WOODBERRY FOREST ADDITIONS SUBDIVISION

APPLICATION NUMBER 6 DATE August 4, 2011

APPLICANT Woodberry Forest Additions Subdivision

REQUEST Subdivision

DETAIL SITE PLAN

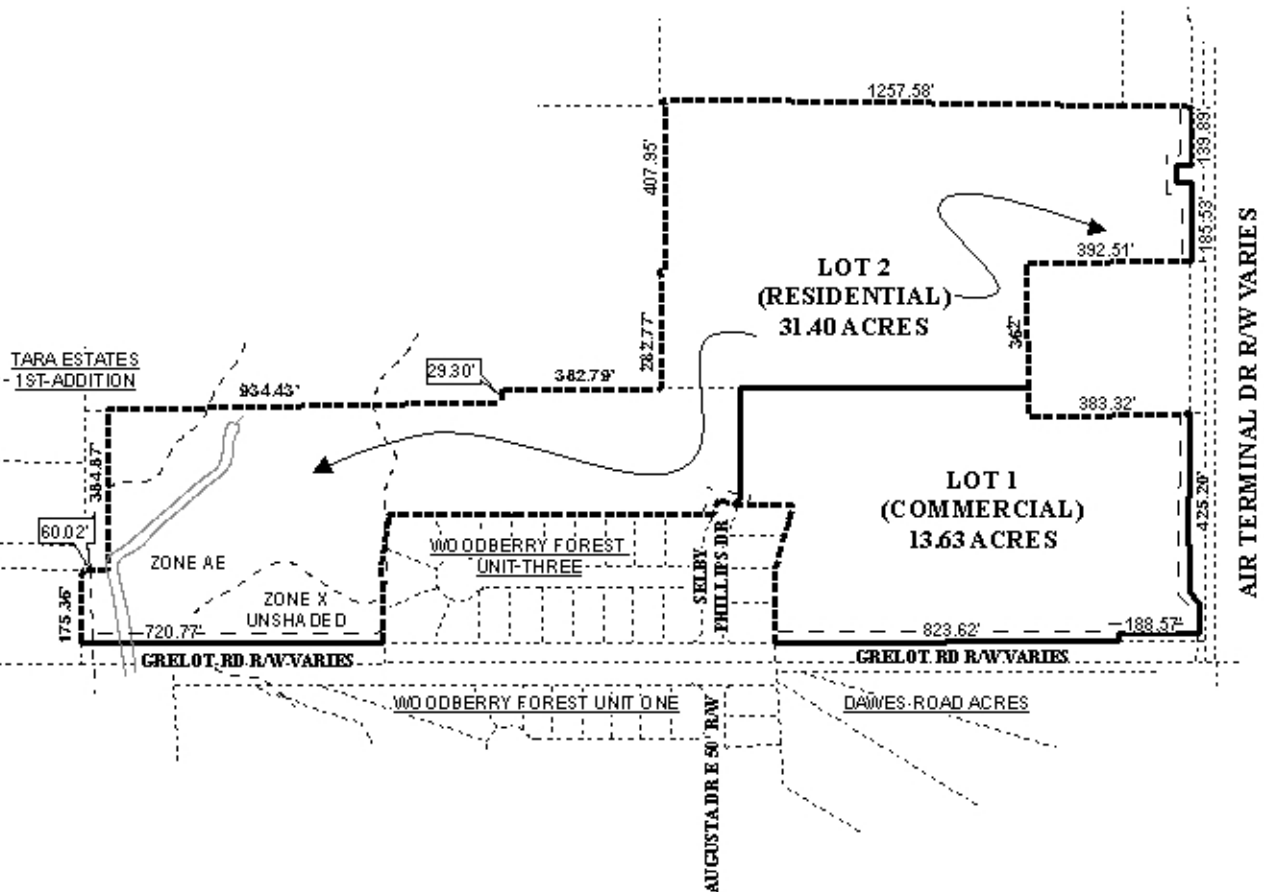
The plat illustrates the proposed 45.0± acre, 2-lot subdivision, which is located at the Northwest corner of Air Terminal Drive and Grelot Road, within the planning jurisdiction. The applicant states that the site is served by public water and sewer services. The purpose of this application is to create two legal lots of record from four existing metes-and-bounds parcels. The site has been the subject of several previous subdivision applications. It was originally approved as Springfield Subdivision with 109 lots in March, 2005; however only 23 lots were recorded in 2006 as Woodberry Forest Subdivision, Unit Three. Woodberry Forest Additions Subdivision was approved in March, 2008, as a 78-lot subdivision, but never recorded, and again approved in October, 2010, as a 92-lot subdivision, but again never recorded. The current application seeks approval as two large lots; one with 31.4± acres for future residential development and one with 13.6± acres for future commercial development.

The boundary lines for the proposed subdivision are essentially the same as for the 2010 approval, except that required dedications along Air Terminal Drive and Grelot Road have been satisfied via County acquisitions. Therefore, no further dedications would be required. The 25' minimum building setback line along all street frontages is shown on the plat. Although no development is proposed at this time, a note should be required on the Final Plat stating that the location, size, and design of all curb cuts are to be approved by County Engineering, and conform to AASHTO standards. As on the preliminary plat, the lots should be labeled on the Final Plat with their sizes in acres, or a table should be furnished providing the same information.

It should be noted that the Southwest portion of proposed Lot 2 is located within NWI wetlands associated with Miller Creek and in the X-shaded, and AE flood zone, as shown on FEMA Flood Insurance Rate Maps. The presence of wetlands and floodplains would indicate that the area may be environmentally sensitive; therefore, if this application is approved, the approval of all applicable federal, state and local environmental agencies would be required prior to the issuance of any permits or land disturbance activities.

This site is located in the County, thus any lots which are developed commercially and adjoin residentially developed property must provide a buffer, in compliance with Section V.A.8. of the Subdivision Regulations.

- 1) depiction of the 25' minimum building setback line along all street frontages as shown on the preliminary plat;
- 2) placement of a note on the Final Plat stating that the location, size and design of all curb cuts are to be approved by County Engineering and conform to AASHTO standards;

- 3) labeling of each lot with its size in acres, or the furnishing of a table on the Final Plat providing the same information;
- 4) placement of a note on the Final Plat stating the development will be designed to comply with the storm water detention and drainage facility requirements of the City of Mobile storm water and flood control ordinances, and requiring submission of certification from a licensed engineer certifying that the design complies with the storm water detention and drainage facility requirements of the City of Mobile storm water and flood control ordinances prior to the issuance of any permits. Certification is to be submitted to the Planning Section of Urban Development and County Engineering;

- 5) placement of a note on the Final Plat stating that approval of all applicable Federal, state and local agencies is required for wetland and floodplain issues, prior to the issuance of any permits or land disturbance activities;

- 6) placement of a note on the Final Plat stating that development of the site must be undertaken in compliance with all local, state and Federal regulations regarding endangered, threatened or otherwise protected species; and

- 7) placement of a note on the Final Plat stating that any lots which are developed commercially and adjoin residentially developed property must provide a buffer, in compliance with Section V.A.8. of the Subdivision Regulations.
